City of Surrey
PLANNING & DEVELOPMENT REPORT

Files: 7915-0095-00
 7915-0098-00
 7916-0672-00

Planning Report Date: December 19, 2016

PROPOSAL:

Option A
Proposed 15-Lot Subdivision of 6221 and 6239 - 188 Street
(Preferred by Applicant)

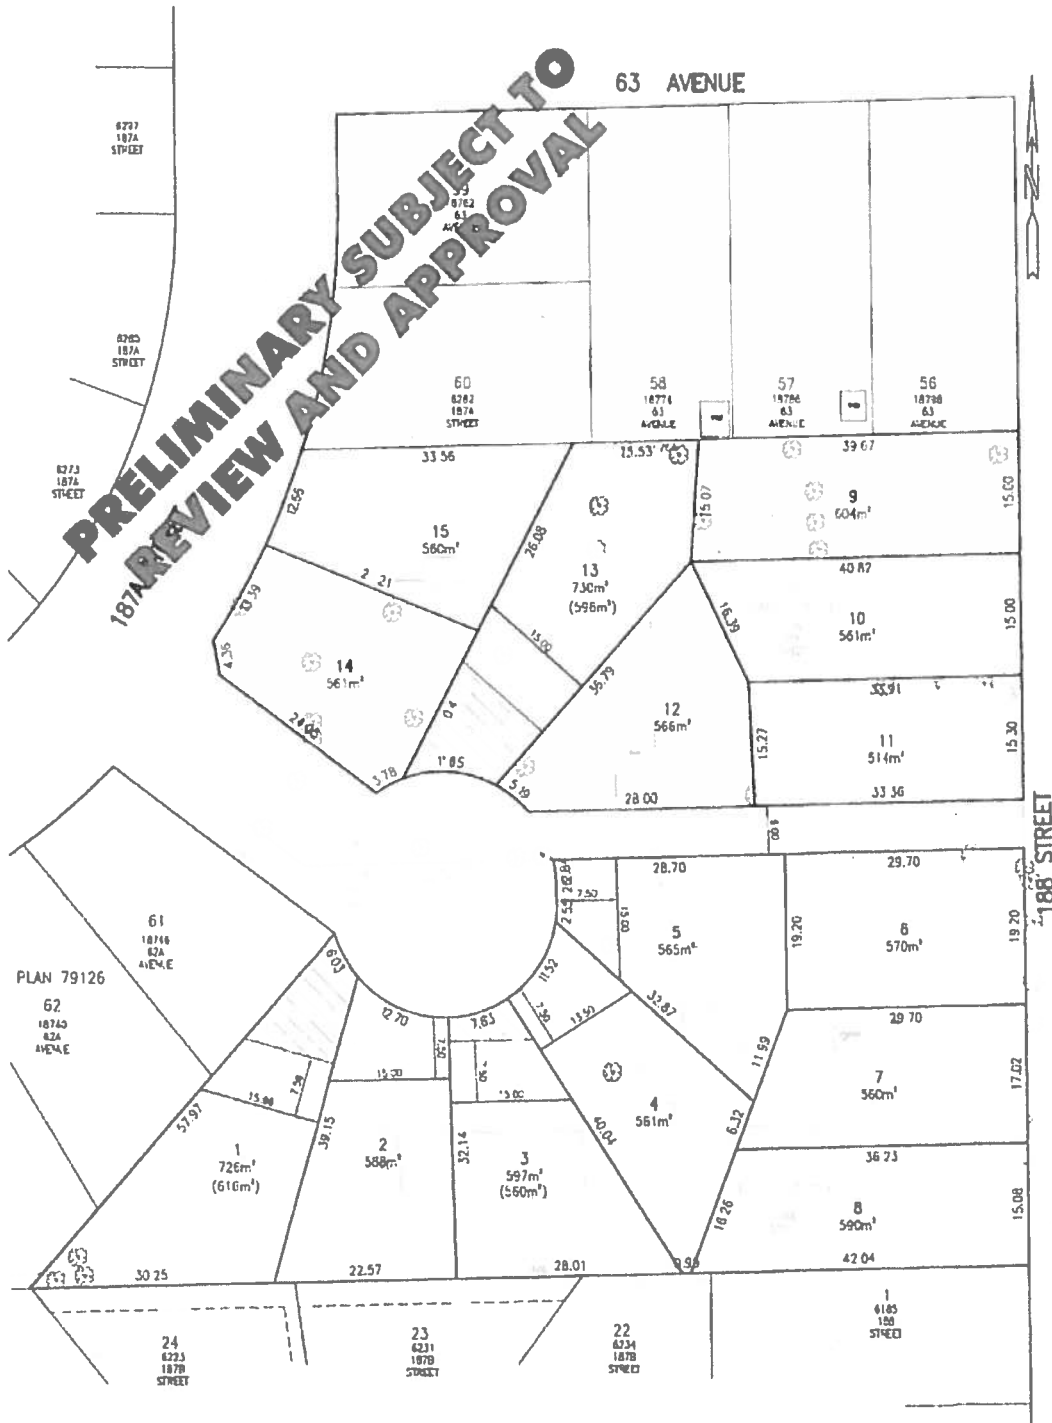
- Invitations to the hearing were sent to all those who, in the opinion of the Approving Officer, are affected by the proposed subdivision. Invitations were sent to a total of 336 properties in an area generally bounded by 63B Avenue to the north, 61A Avenue to the south, 186 Street to the west and 189A Street to the east, with an extension south to 60 Avenue for properties fronting 188 Street. The invitation letters included both layout options; Option A with cul-de-sac access to 187A Street/62A Avenue and Option B with cul-de-sac access to 188 Street (Appendix III).

- A total of 32 speakers provided input at the July 21, 2016 hearing, with 11 speakers in favour of Option A and 21 speakers in favour of Option B.
- After considering the comments raised at the Approving Officer Hearing the Approving Officer ultimately reached a conditional decision on the proposed subdivision. In arriving at this decision, the Approving Officer considered by-laws and policies, neighbourhood evolution and existing character, and the public interest (including input from the speakers at the Approving Officer Hearing and the two petitions previously received). The Approving Officer also undertook a pros and cons analysis of the two layout options.

- The Approving Officer concluded that neither Option A nor Option B could be approved, however, the Approving Officer advised the applicant that should specific modifications be made to Option B to maximize on-street parking on the west side of 188 Street and within the proposed cul-de-sac bulb and to minimize driveways onto 188 Street, an acceptable layout could be achieved.

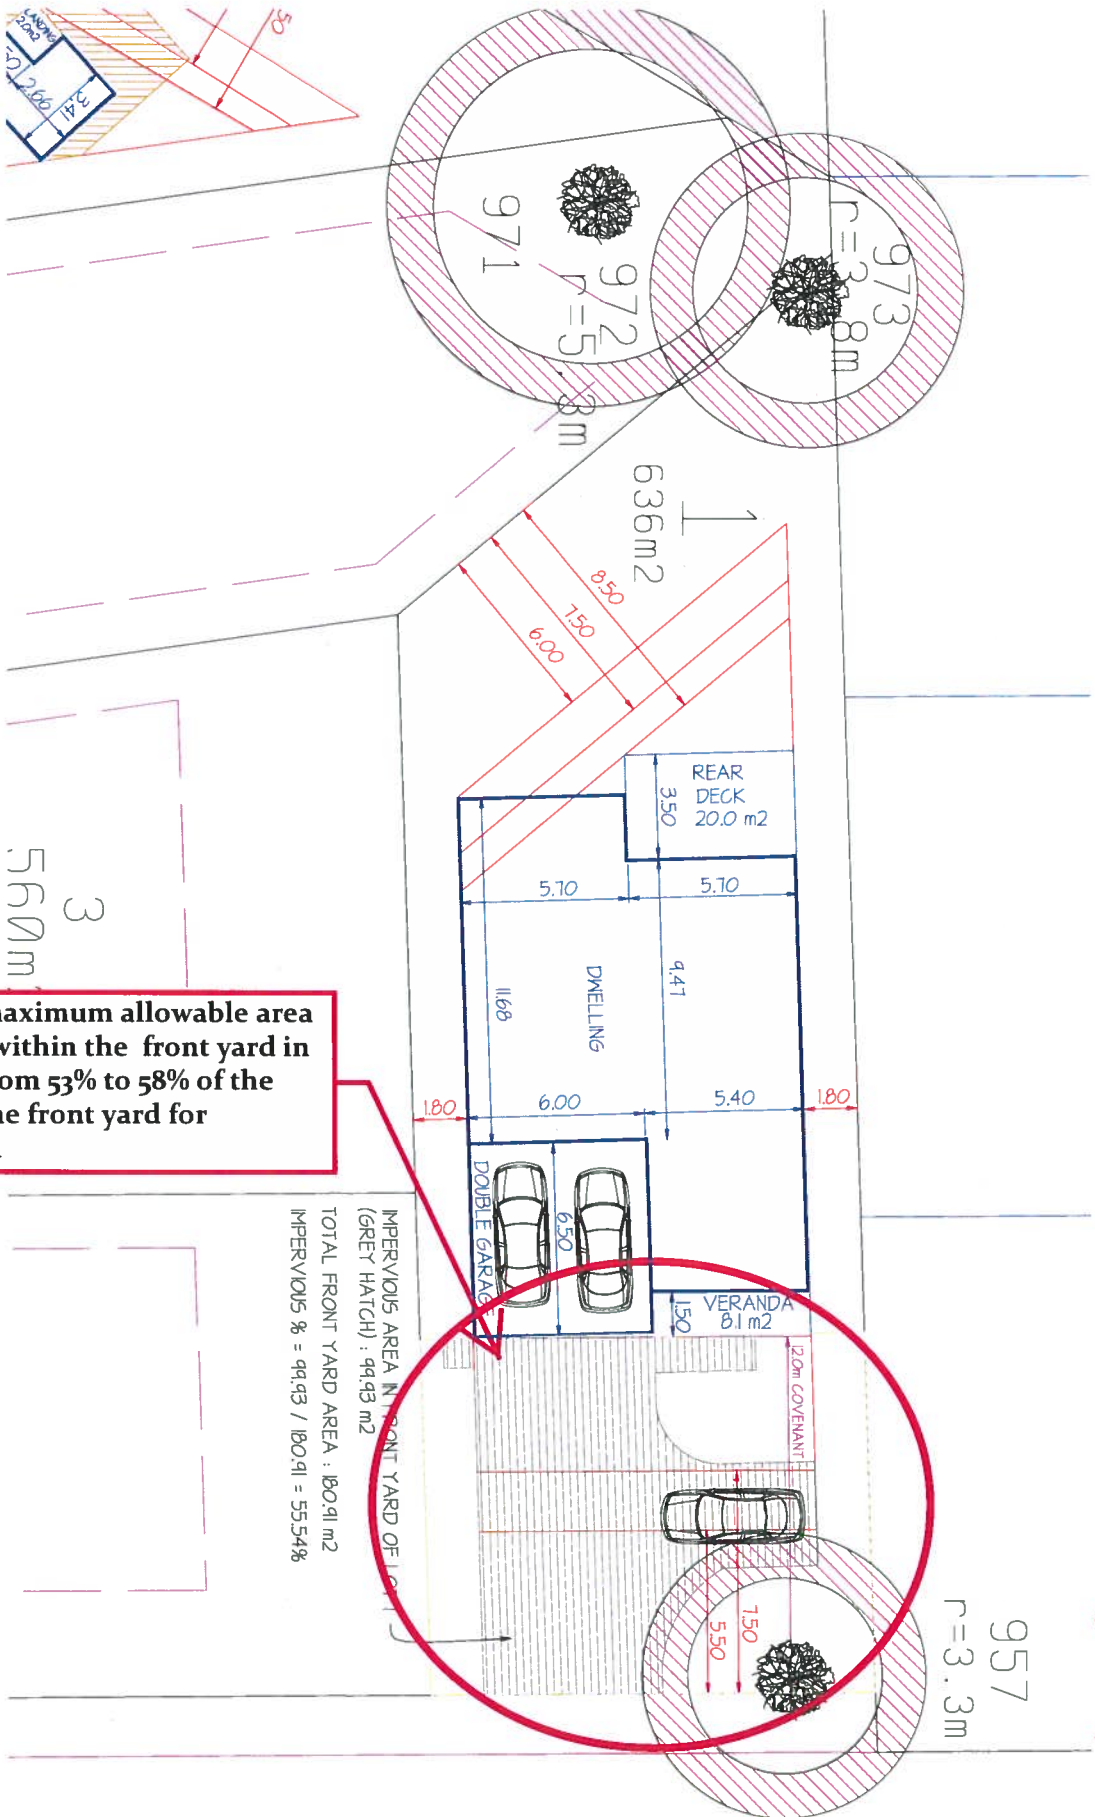
increase the maximum allowable area of a driveway within the front yard in the RF Zone from 53% to 58% of the total area of the front yard for proposed Lot 1

IMPERVIOUS AREA IN FRONT YARD OF LOT 1 (GREY HATCH) : 99.93 m²
 TOTAL FRONT YARD AREA : 180.91 m²
 IMPERVIOUS % = 99.93 / 180.91 = 55.54%

- The RF Zone prohibits a driveway from exceeding 53% of the total area of the front yard to limit impervious areas. The proposed variance will increase this requirement to 58% in order to allow a driveway turnaround on Lot 1, which is the only proposed lot fronting 188 Street.

- The proposed driveway turnaround within the front yard will prevent residents from either backing in from or backing onto 188 Street, which is a busy collector road. Backing onto 188 Street is a concern that was raised by residents in the area.

- Proposed Lot 1 is approximately 36 metres (119 ft.) deep which allows for the dwelling to be setback 12 metres (39 ft.) from the front lot line along 188 Street. The increased setback will be secured through a restrictive covenant that will be required as a condition of subdivision approval.

- The applicant has demonstrated that the proposed driveway turnaround can be located outside of the tree protection area of the Mountain Ash tree proposed to be retaining in the front yard of proposed Lot 1.

- Staff supports the requested variance.

Lot 9

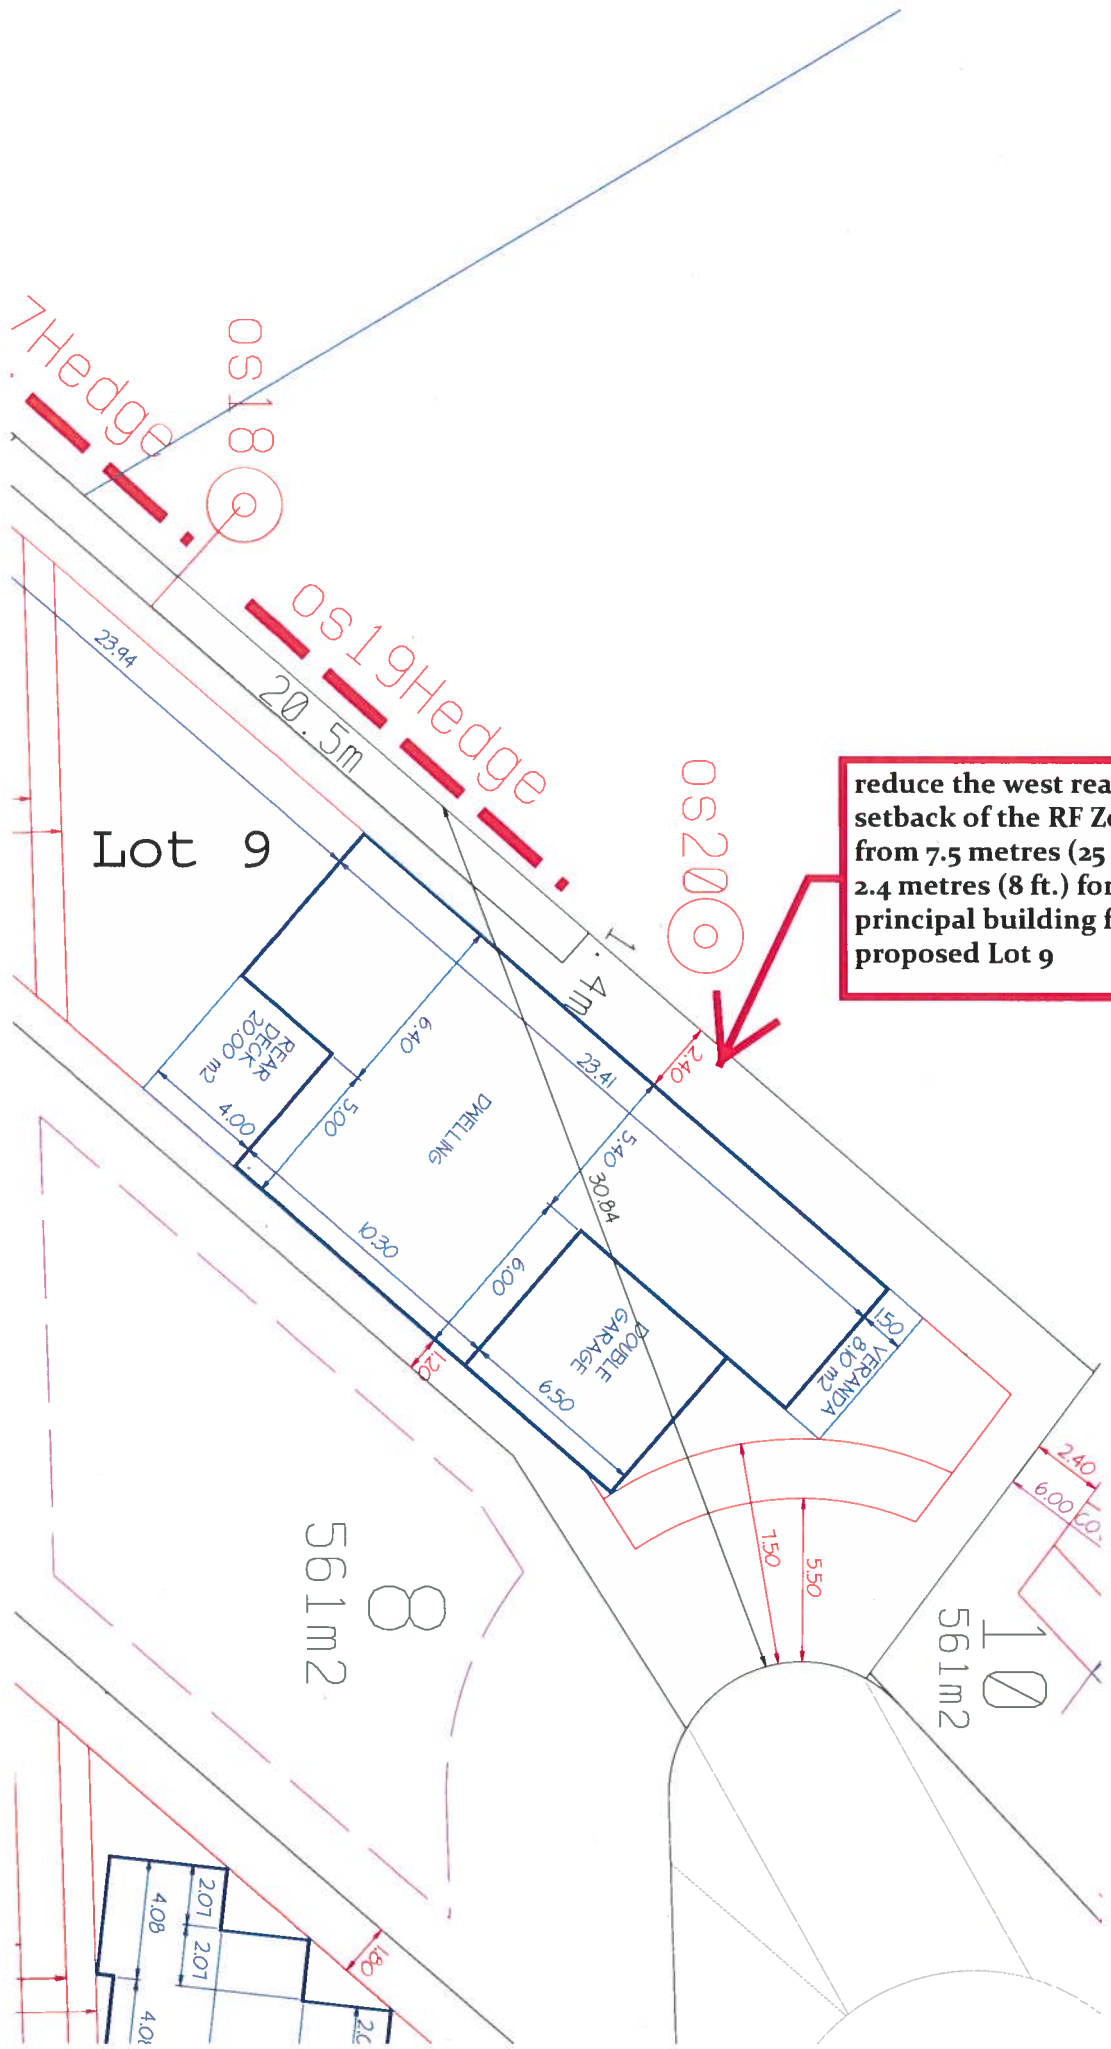
reduce the west rear yard setback of the RF Zone from 7.5 metres (25 ft.) to 2.4 metres (8 ft.) for the principal building for proposed Lot 9

- Proposed Lot 9 is an irregular shaped lot. Due to the angle of the lot and the location of the frontage on the cul-de-sac, both the west and south lot lines are considered rear lot lines in the Zoning By-law. Applying the typical rear yard setbacks along these two lot lines would render the lot unbuildable.

- The applicant's design consultant has provided a building footprint analysis that illustrates that by reducing the setback along the west lot line from 7.5 metres (25 ft.) to 2.4 metres (8 ft.) a functional building envelope can be achieved. Essentially this results in the west lot line functioning as a side lot line as opposed to a rear lot line.

- The proposed building configuration still accommodates a functional rear yard in the south portion of proposed Lot 9.
- The proposed 2.4-metre (8 ft.) west yard setback will allow for the protection of the neighbouring cedar hedge and allow for the installation of additional landscaping to be planted along this lot line for screening purposes. A landscaping plan and bonding to secure installation of the hedging will be secured as a condition of subdivision approval.

- The proposed building scheme will incorporate a number of design criteria which may include offsetting upper floors, limiting floor to ceiling heights and stipulating basement elevations on interface lots including proposed Lot 9. These details will be confirmed with the applicant's design consultant prior to subdivision approval.

- Staff supports the requested variance.

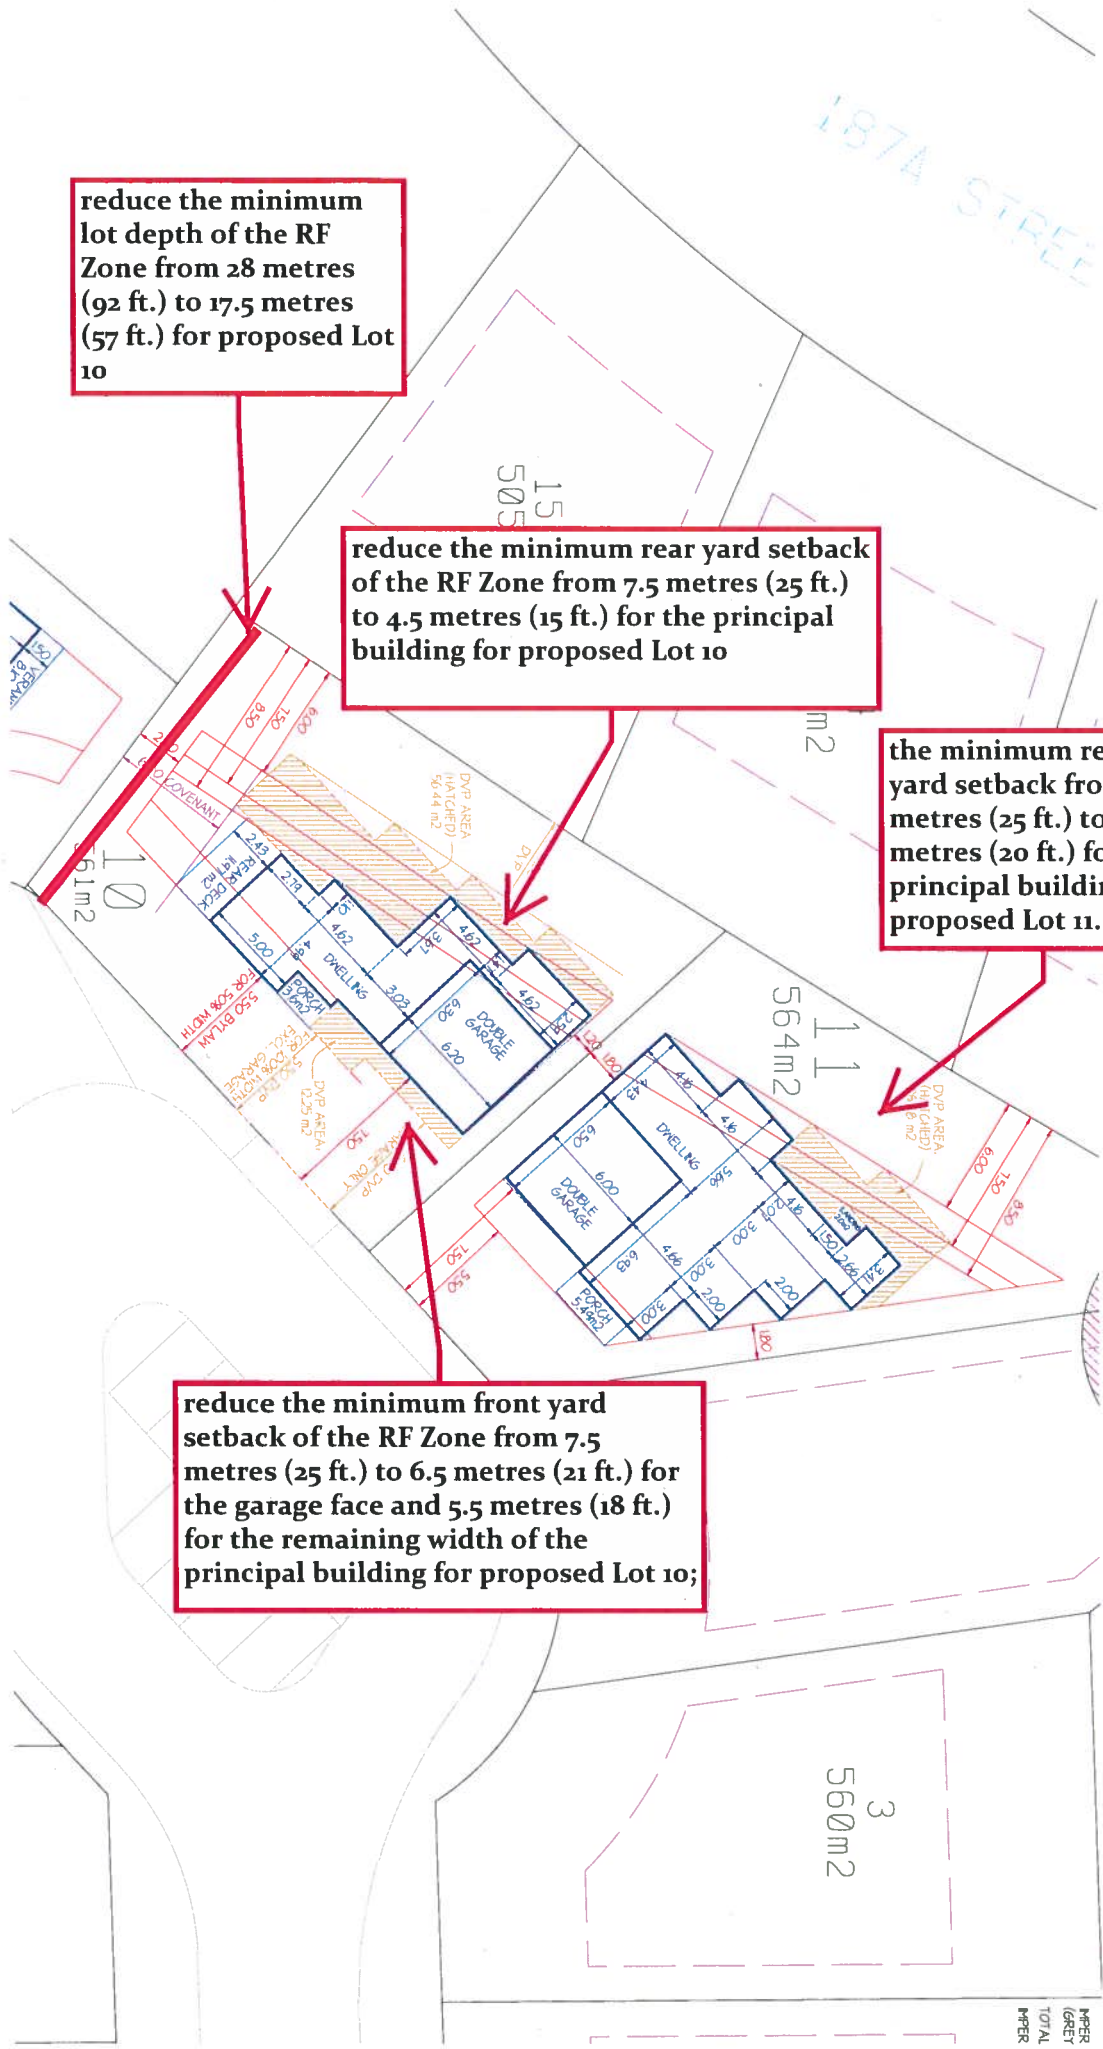
reduce the minimum lot depth of the RF Zone from 28 metres (92 ft.) to 17.5 metres (57 ft.) for proposed Lot 10

reduce the minimum rear yard setback of the RF Zone from 7.5 metres (25 ft.) to 4.5 metres (15 ft.) for the principal building for proposed Lot 10

the minimum rear yard setback from 7.5 metres (25 ft.) to 6 metres (20 ft.) for the principal building for proposed Lot 11.

reduce the minimum front yard setback of the RF Zone from 7.5 metres (25 ft.) to 6.5 metres (21 ft.) for the garage face and 5.5 metres (18 ft.) for the remaining width of the principal building for proposed Lot 10;

- In reply to resident concerns regarding parking impacts of the proposed subdivision, an elongated cul-de-sac with a 9-stall parking island is proposed. The elongated cul-de-sac reduces the space between the western edge of the cul-de-sac bulb and the eastern edge of 187A Street, requiring reduced lot depth on proposed Lot 10.

- Proposed Lot 10 meets the minimum lot area requirements of the RF Zone and is a wider than a typical RF lot (23 metres/75 ft. vs. 15 metres/50 ft.).
- The proposed reduced front and rear yard setbacks are required to accommodate a more functional building envelope and a floor area that is closer to the maximum allowable in the RF Zone. Without the proposed setback relaxations, an approximately 208-square metre (2,237 sq. ft.) dwelling could be constructed. With the variances approved, an approximately a 331-square metre (3,568 sq. ft.) dwelling could be constructed.

- The applicant's design consultant has provided a building footprint analysis which provides for an increased southwest side yard from 1.8 metres (6 ft.) to 6 metres (20 ft.) which will add to the functional outdoor yard space together with the 4.5-metre (15 ft.) rear yard setback. The increased southwest side yard setback will be secured through a restrictive covenant as a condition of subdivision approval.

- The proposed setback relaxations will still allow for up to 5 full sized parking spaces to be provided on proposed Lot 10; two (2) in the garage and up to 3 on the driveway.

- Proposed Lot 10 is largely interior to the subdivision and as such the proposed variances are anticipated to have minimal impact on existing neighbouring residents.
- Staff supports the requested variance.
